SUBJECT: ISSUANCE OF AMENDMENT NO. 24 TO FACILITY OPERATING LICENSE  
NO. NPF-41 FOR THE PALO VERDE NUCLEAR GENERATING STATION,  
UNIT NO. 1 (TAC NOS. 65460, 65461, 65462 AND 65691 THROUGH 65706)

PALO VERDE NUCLEAR GENERATING STATION, UNIT NO. 1

Amendment No. 24  
License No. NPF-41

ENCLOSURE TO LICENSE AMENDMENTAMENDMENT NO. 24 TO FACILITY OPERATING LICENSE NO. NPF-41DOCKET NO. STN 50-528

FIGURE 3.1- 1A

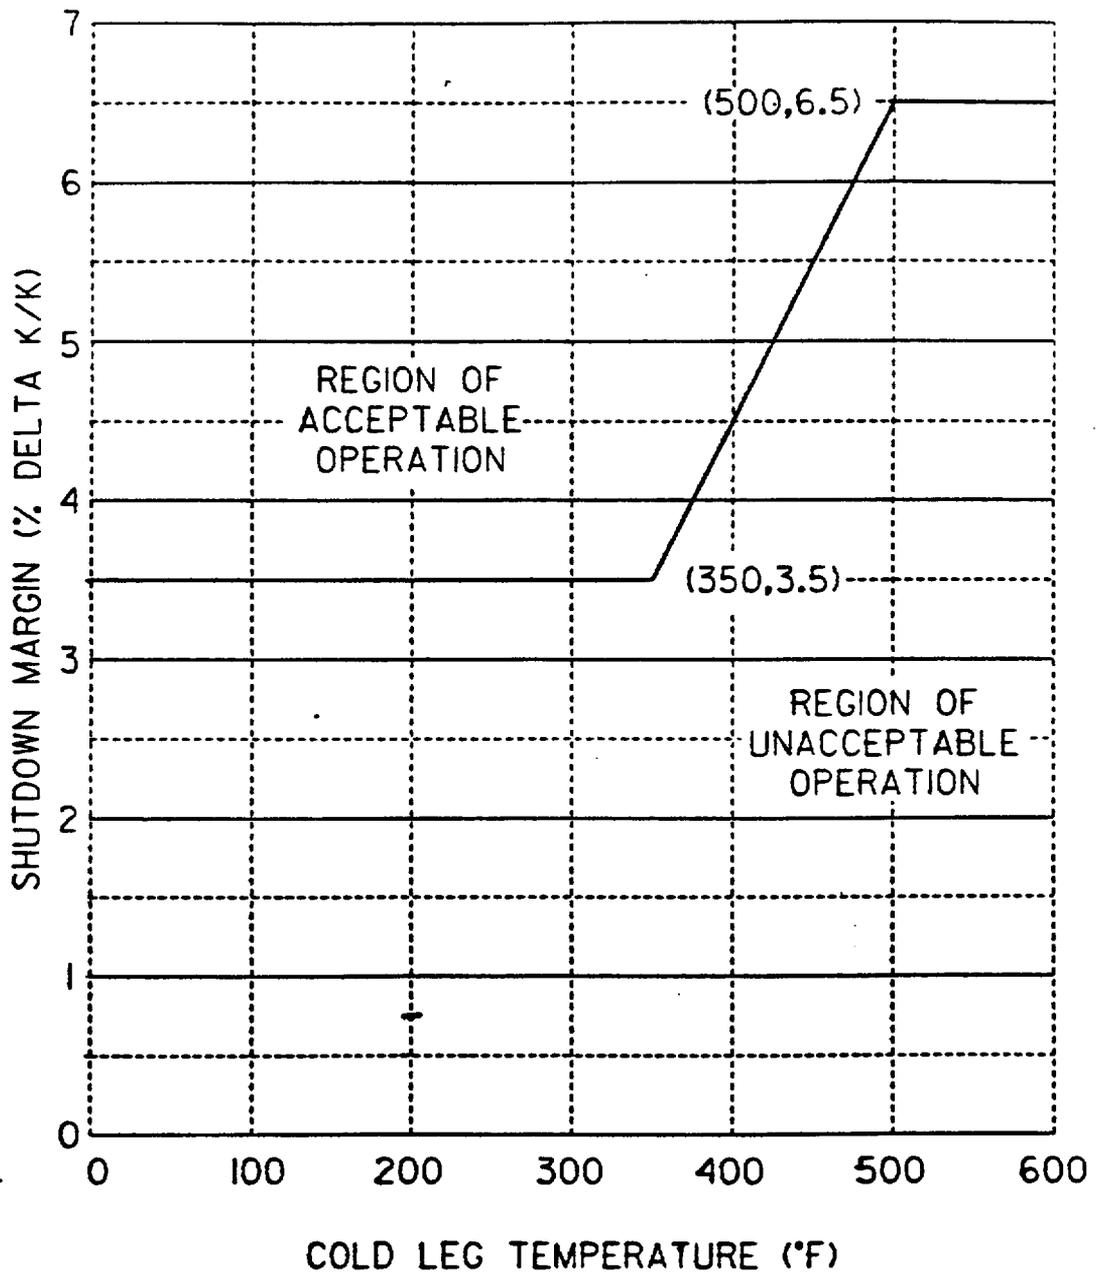
- (2) The shutdown margin versus cold leg temperature curve given in Figure 3.1-1A of Technical Specification 3.1.1.2 has been changed to increase the required shutdown margin value from 6.0% delta k/k to 6.5% delta k/k at cold leg temperatures above 500°F.

The increased shutdown margin is required to ensure that the steam-line break event at hot zero power, which is the most limiting accident with regard to shutdown margin requirements for Cycle 2, is bounded by the reference cycle (Cycle 1) analysis. Sufficient CEA trip reactivity worth is available to meet the shutdown margin requirements even with the most reactive CEA assumed stuck in the fully withdrawn position. The staff, therefore, finds this change acceptable.

FIGURE 3.1-1

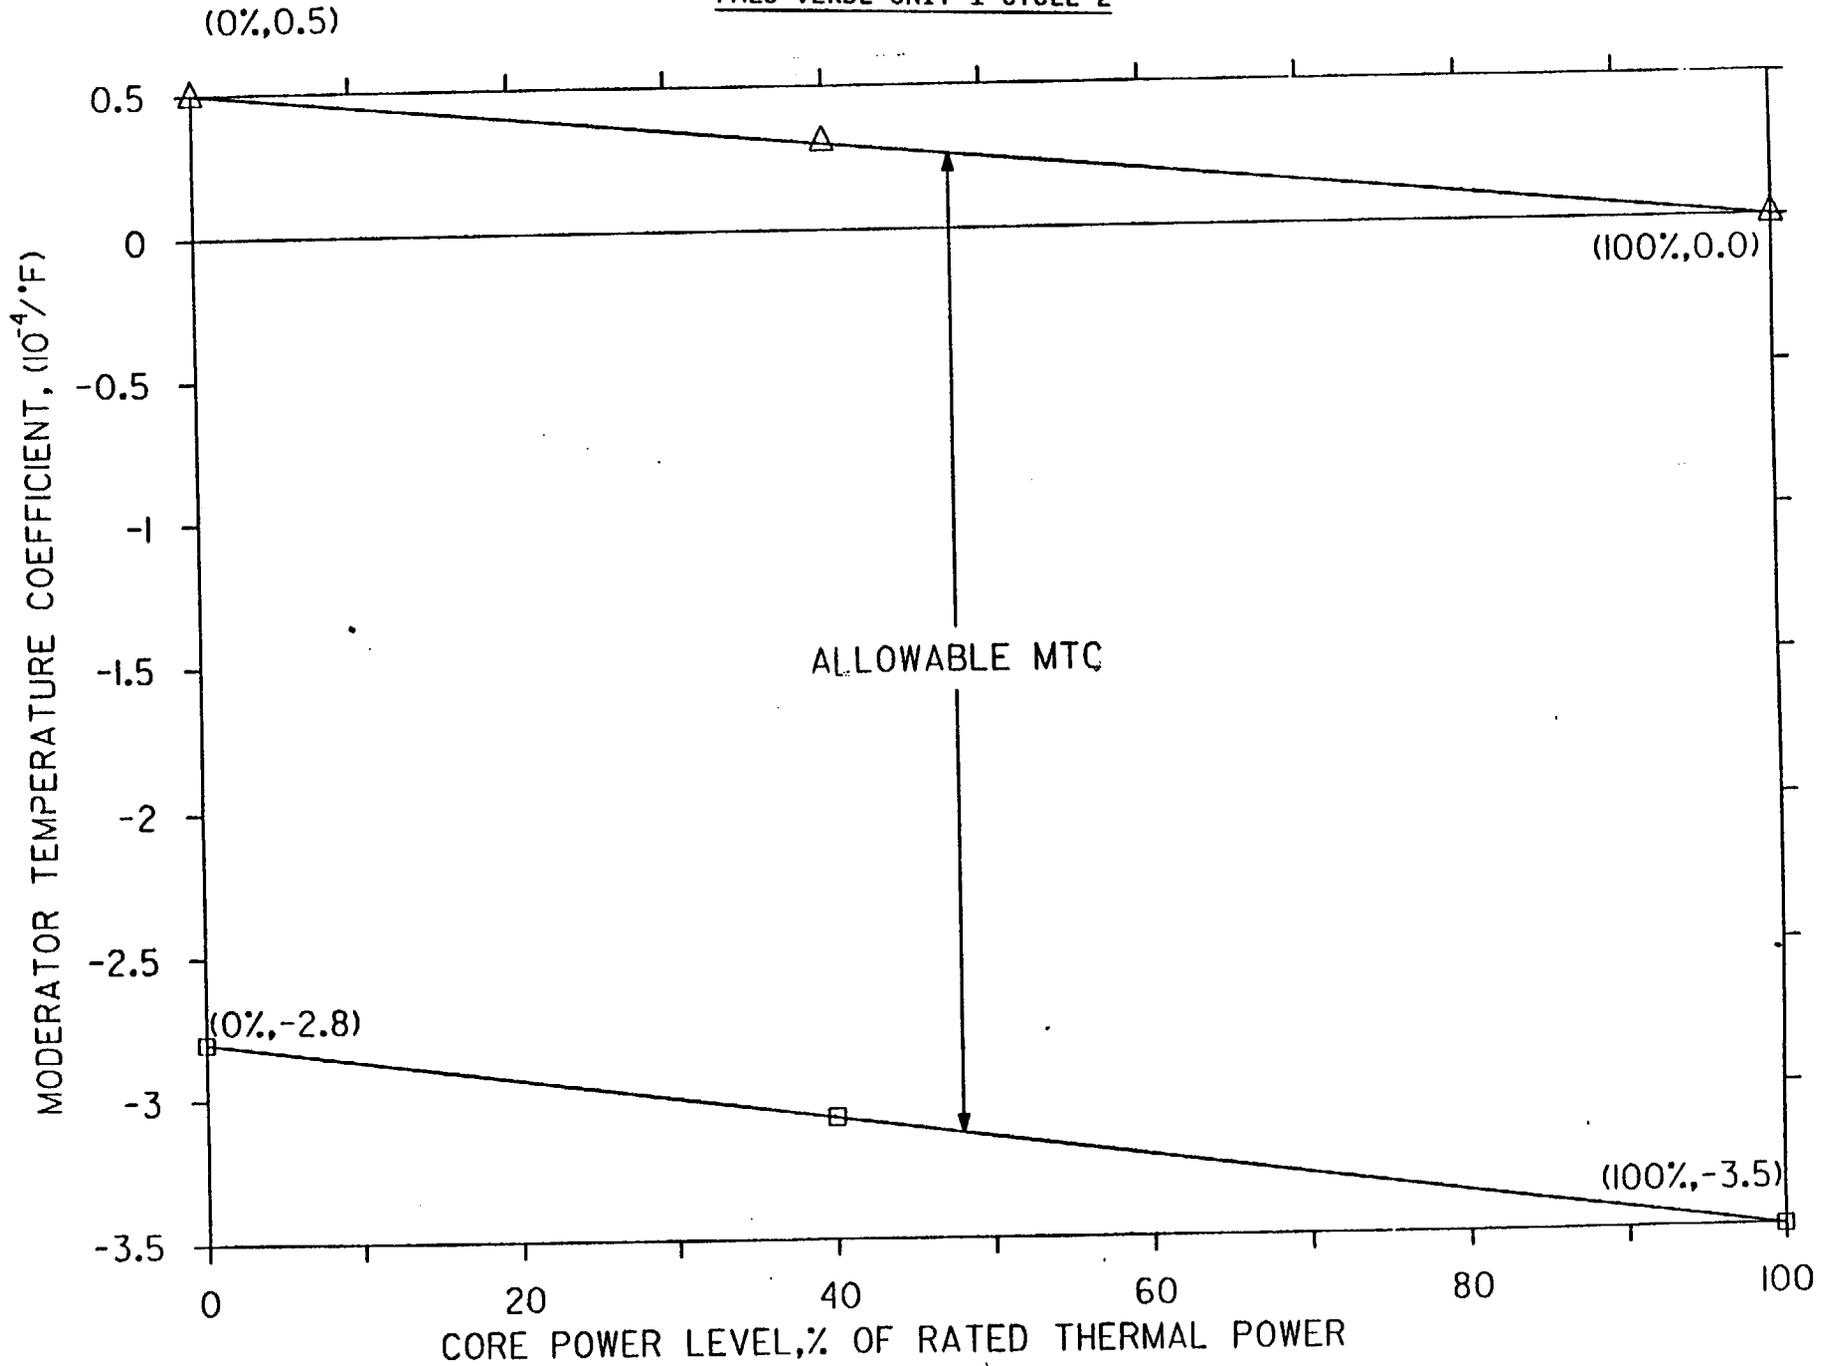
- (3) The moderator temperature coefficient (MTC) operating band, given in Figure 3.3-1 of Technical Specification 3.1.1.3, has been made more positive and the x axis has been changed to core power level instead of average moderator temperature.

FIGURE 3.1-3

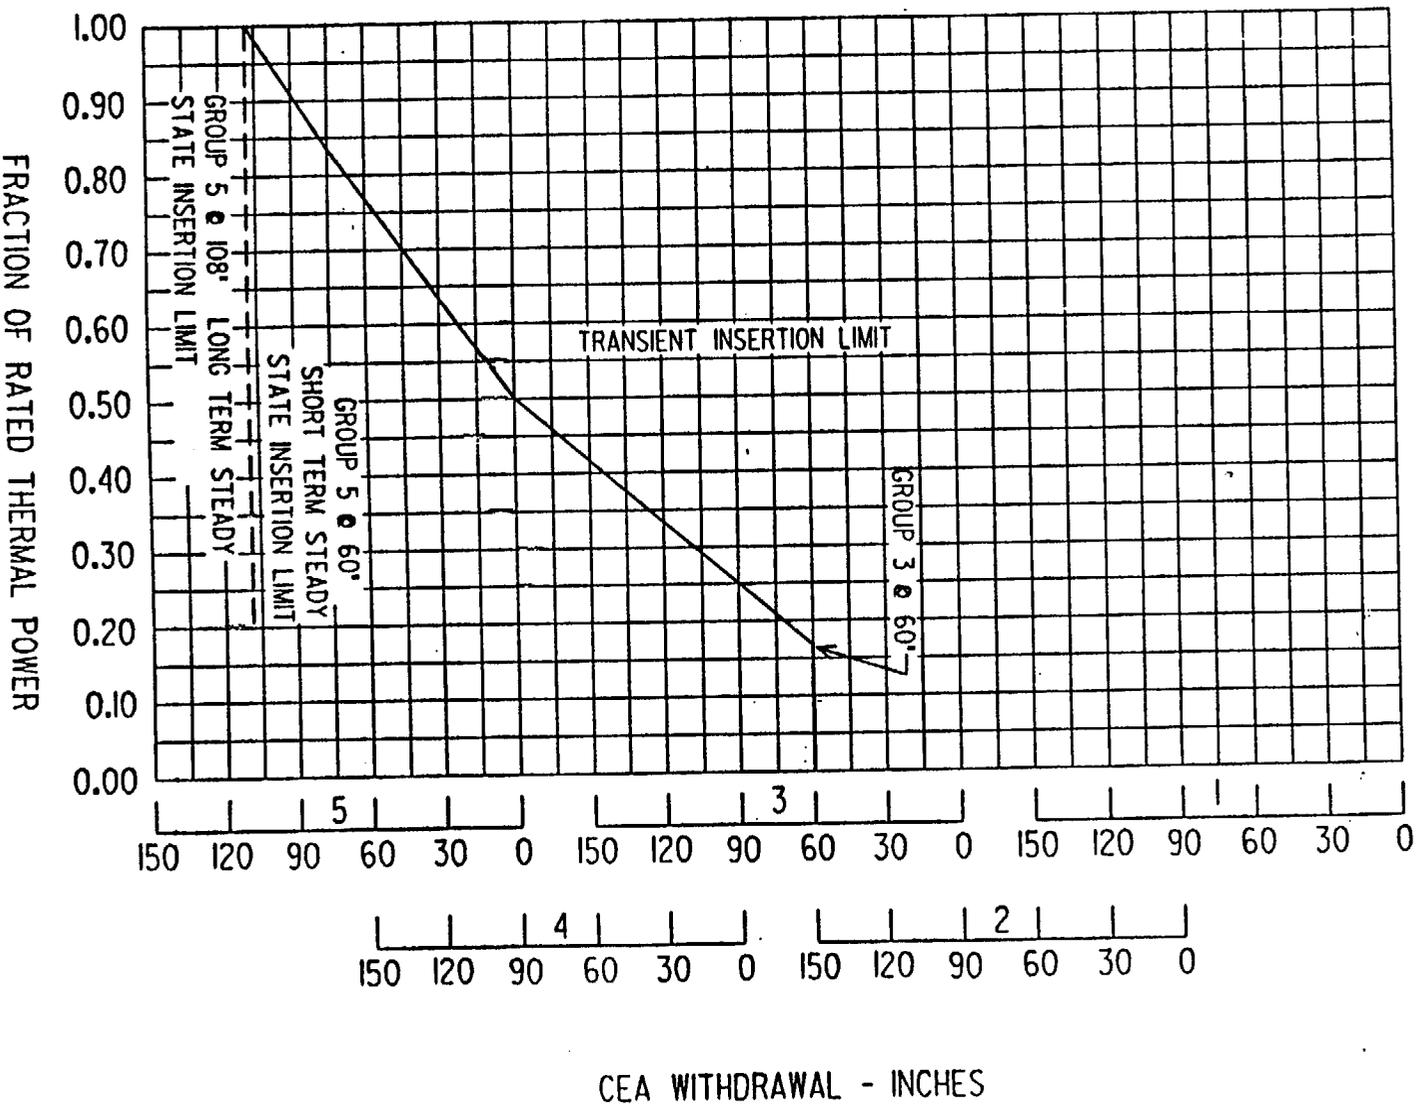
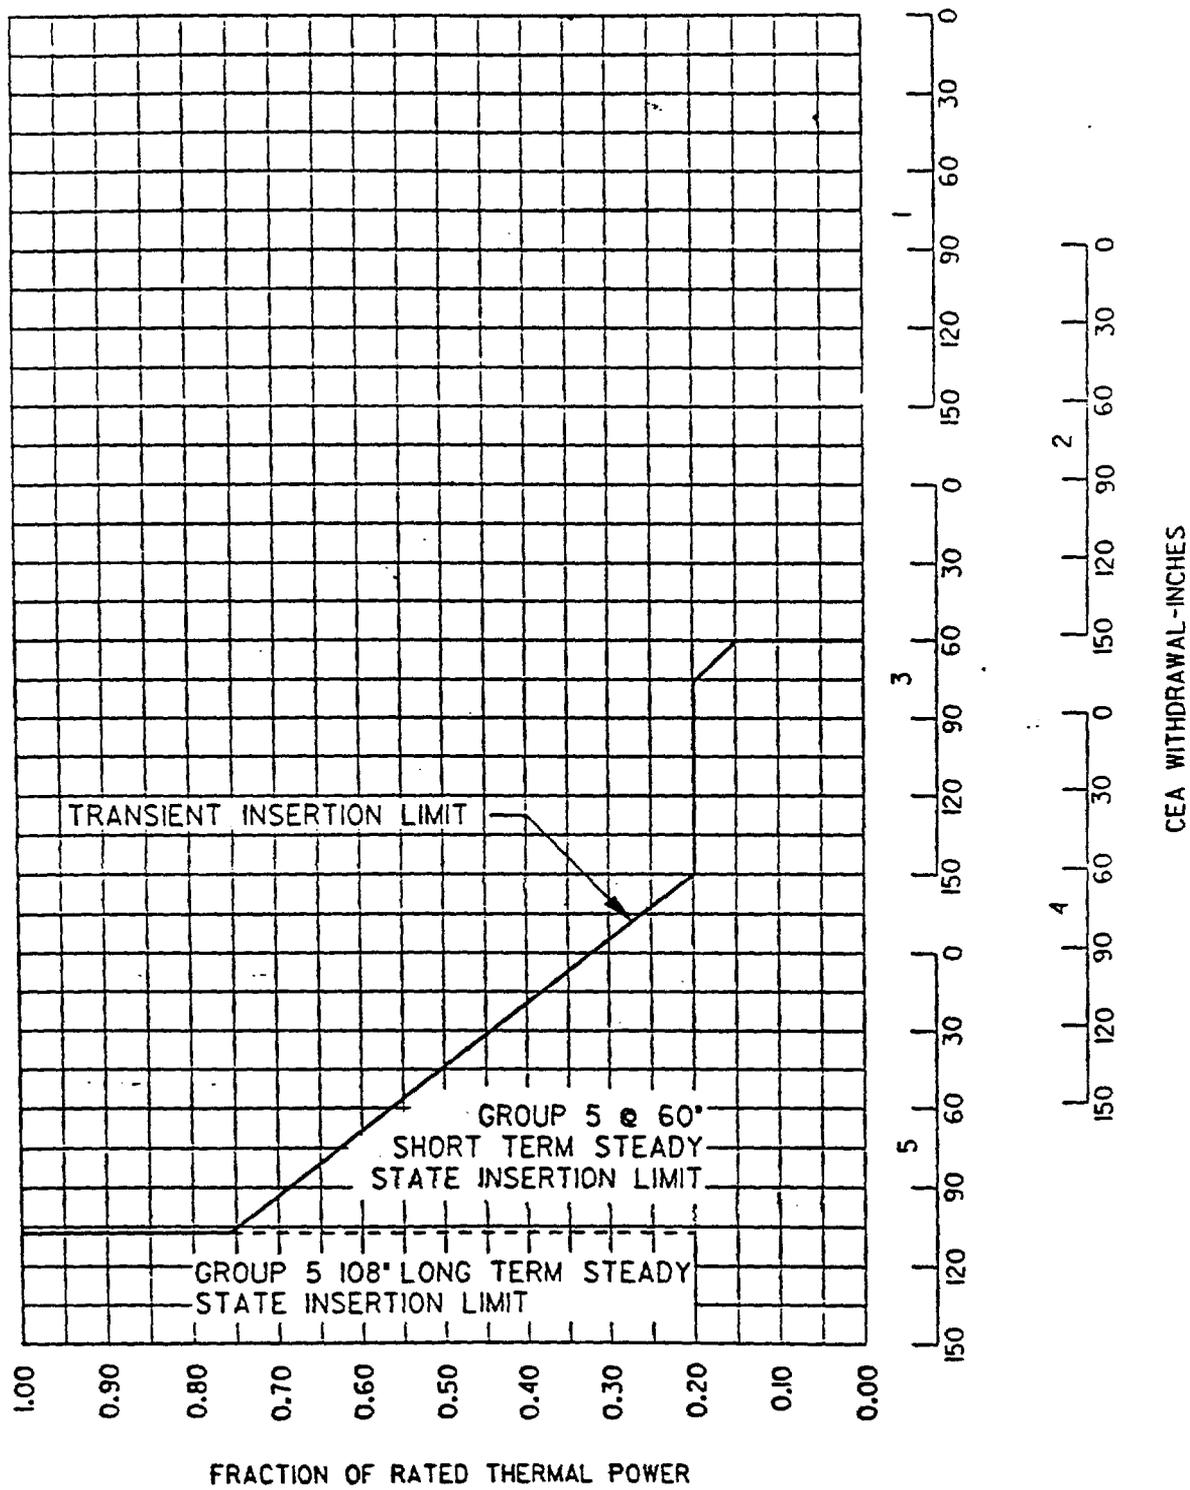
- (8) The CEA insertion limits given in Technical Specification 3.1.3.6 have been revised to account for changes in the reactivity worth of the CEAs due to the changes in Cycle 2 core.

Since the reactivity worth of the CEAs has changed, the consequences of the dropped and ejected CEA events are affected. The revised CEA insertion limits chosen, which were calculated by approved methods, ensure that there is sufficient margin to mitigate such events during Cycle 2. The CEA insertion limit revision is, therefore, acceptable.

FIGURE 3.1-5  
 PART LENGTH CEA INSERTION LIMIT VS THERMAL POWER

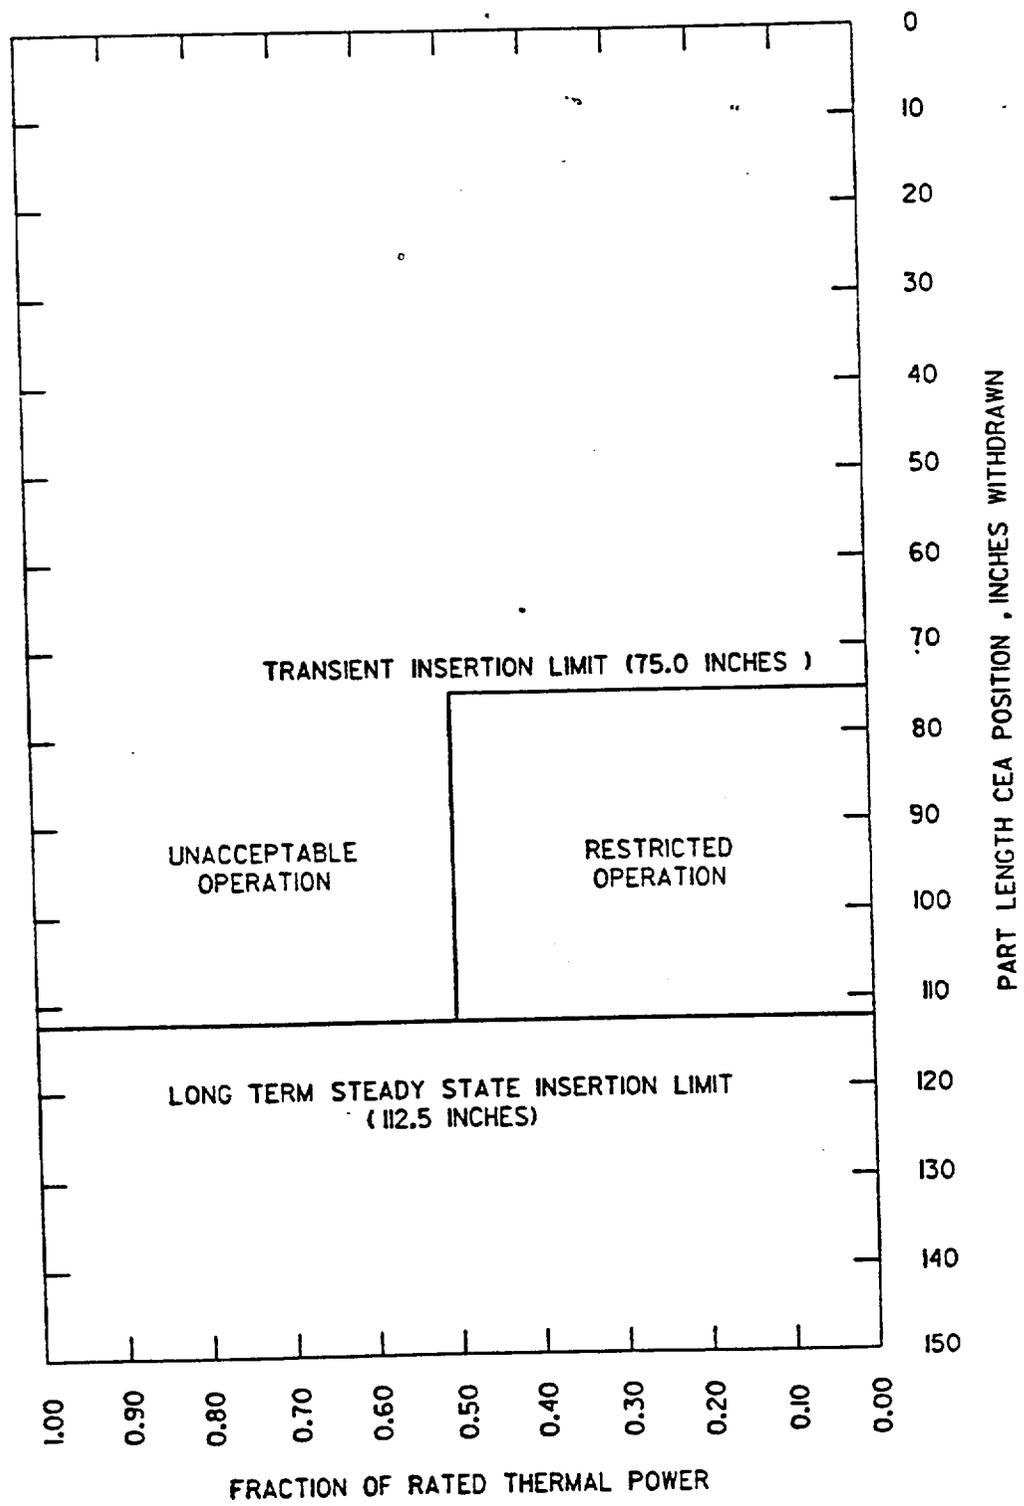
- (5) Reference to the part length CEA insertion limits have been removed from Technical Specification 3.1.3.1 and a new Specification 3.1.3.7 has been added to specify the length of time for insertion and the insertion limit of the part length CEAs specifically.

The new Specification adds a more explicit LCO to clarify the allowable duration for a part length CEA to remain within the defined ranges of axial position and reduces the potential adverse consequences of a part length CEA drop or misalignment from an allowable position. The changes are, therefore, acceptable.
